SITE/SOIL EVALUATION for ON-SITE WASTEWATER SYSTEMS

Attached is a proposed design for an Accepted (25% reduction) Septic System with Pressure Manifold distribution for a 4 bedroom single family residence on PIN 4624232134, Lot #430 CL&T Subdivision, Iredell County, North Carolina.

September 17, 2014
Project No. 01-2017
Design By: Rollans Soil and Environmental Services, PA

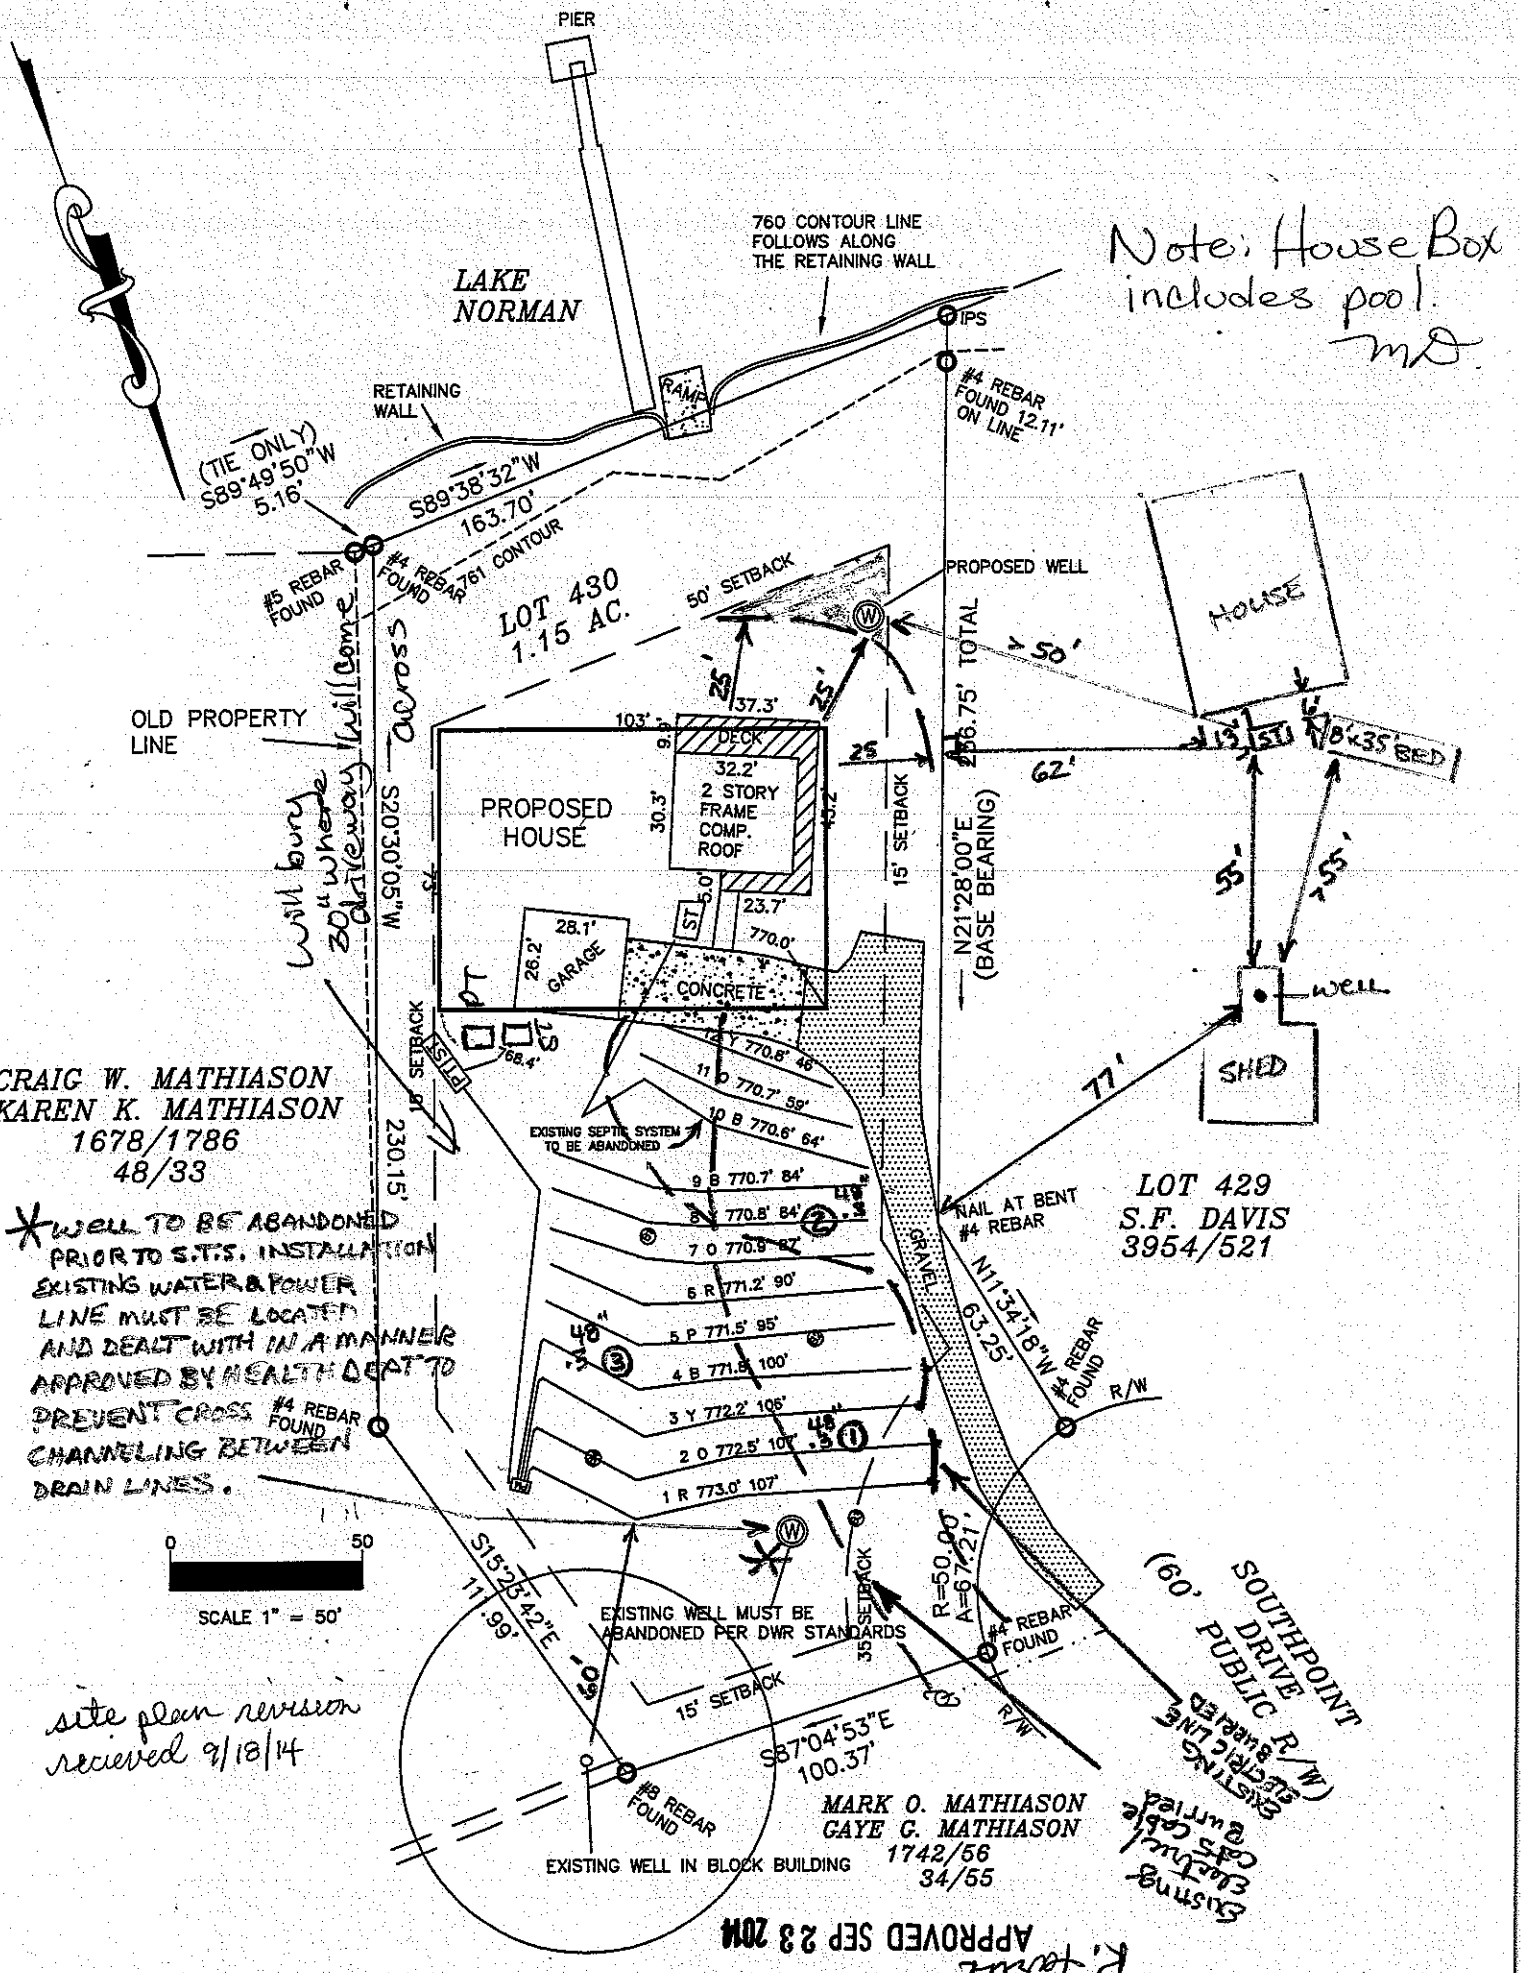
#4 REBAR FOUND
R/W
* WELL TO BE ABANDONED PRIOR TO S.T.S. INSTALLATION EXISTING WATER & POWER LINE MUST BE LOCATED AND DEALT WITH IN A MANNER APPROVED BY HEALTH DEPT TO PREVENT CROSS CHANNELING BETWEEN DRAIN LINES.

#4 REBAR FOUND
0
50
SCALE 1" = 50'
S15°25'42"E 11.99'
EXISTING WELL MUST BE ABANDONED PER DWR STANDARDS
35' SETBACK
R=50.00'
A=67.21'
15' SETBACK
S87°04'53"E 100.37'

#8 REBAR FOUND
EXISTING WELL IN BLOCK BUILDING
MARK O. MATHIASON
GAYE G. MATHIASON
1742/56
34/55
SOUTHPOINT DRIVE (60' PUBLIC R/W)
EXISTING ELECTRIC LINE BURIED
Existing Electric Cable Buried
site plan revision recieved 9/18/14
APPROVED SEP 23 2014

COMMENTS Locate all known water and utilities lines in existing/repair area and propose method to remediate. channel short circuit abandon existing well. Trench depth TBD from known water / sewer line. Verify well locations and STS locations on adjacent lots

site plan revision received 9/18/14

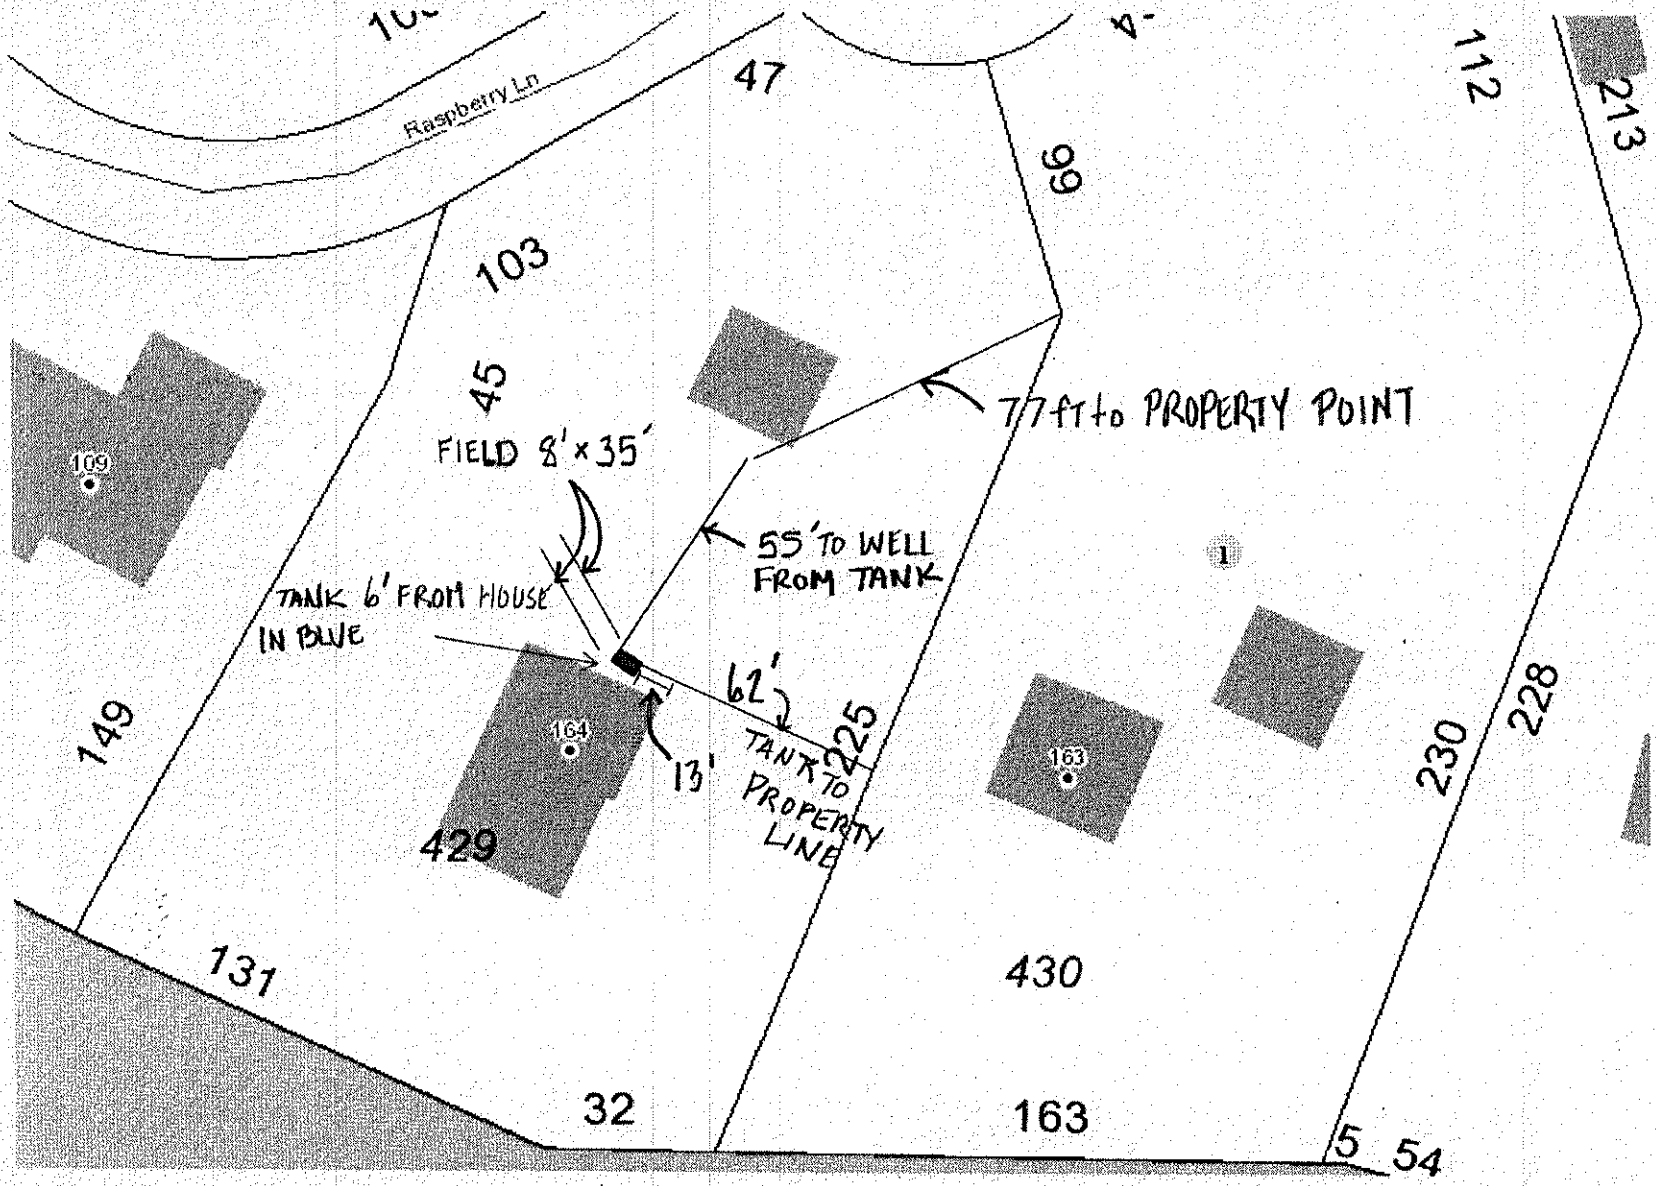
#5 REBAR FOUND
#4 REBAR FOUND
761 CONTOUR
LOT 430 1.15 AC.
50' SETBACK
PROPOSED WELL
well STS? location
OLD PROPERTY LINE
PROPOSED HOUSE
2 STORY FRAME COMP. ROOF
DECK

11' prop corner
Power pole
Electric & Cable
P
R
2'
1'
Y
R
B
4'
P
3'
R
Y
B
52
5'
TOP EXISTING LINE
27'
2'
new house footprint

Richard Farris who is with Iredell County and I spoke this afternoon and he needs you to change a few things on the submittal.

Specifically to show the last farthest from the house line not being installed directly over the well that is to be abandoned. I leave to the two of you what this means for the design.
